MEMORANDUM

From:	Built Heritage Officer	Service:	Green Infrastructure
Application No.	251543 + 251544	Site Visit Made:	Previously.
Address:	Sussex Lodge, Sussex Lane, Spencers Wood, RG7 1BY.		
Proposal:	251543: Application for submission of details to comply with the following condition of planning consent 250179 dated 26/1/2025. Condition 3 relates to Windows and Doors, Condition 4 to Outbuilding Brickwork, Condition 5 to Insulation Measures, Condition 6 to Flinch Plates and Condition 7 to Chimney Breast. 251544: Application for submission of details to comply with the following condition of listed building consent 250178 dated 01/04/2025. Condition 3. Joinery Details. 4. Methodology Statement. 5. Insulation Details. 6. Flinch Plate Details. 7. Chimney Breast Details.		
Relevant built heritage condition text.	3. Notwithstanding the details submitted, no works relating to internal and external windows or doors shall take place until full joinery details to install the hereby permitted replacement windows and doors have been submitted to and approved in writing by the local planning authority within 3 months of the date of this decision. Details are to include: • Documentation, in

Extract of SL108D - note missing small square window adjacent to exterior kitchen door.

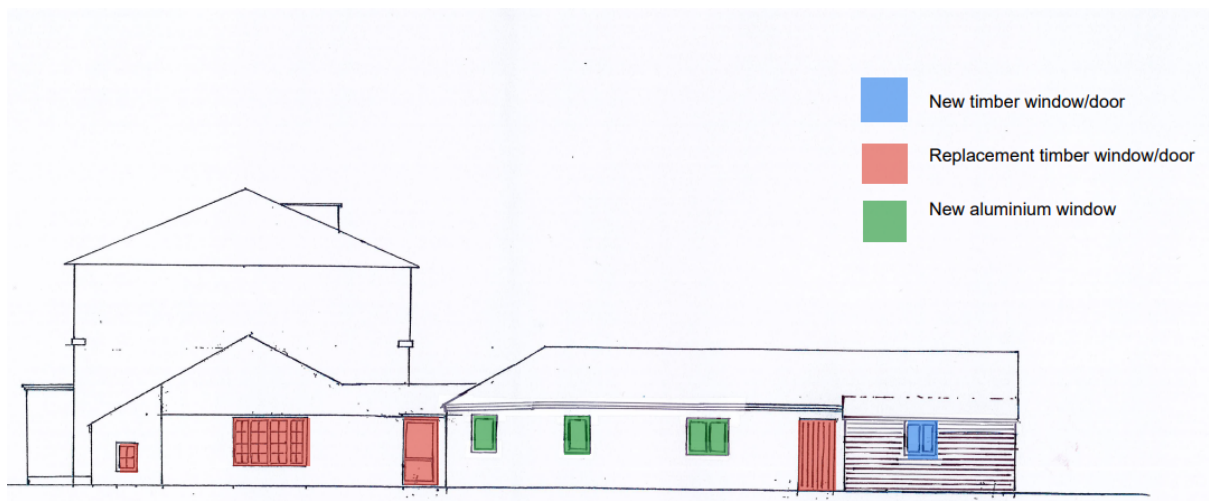
It should also be pointed out, in checking up about whether the windows had been part of the consented works has resulted in it being noted a small square window on the NW facing elevation of the former kitchen has been consistently missed off the existing /proposed plans on all the applicant's pre-application and application submissions.

Given the applicant seeks to replace the windows of the former kitchen and store it seems likely then that the applicant would also be seeking to replace this omitted window to.

The existing 3no. small square windows to the store and that one on the NW facing elevation of former kitchen are from photographic evidence original. Unfortunately there is no clear photographic images of the large kitchen window, which evidently maybe modern and uPVC.

The replacement of these windows would appear to be require the need for a new application to be made and consent given to do so.
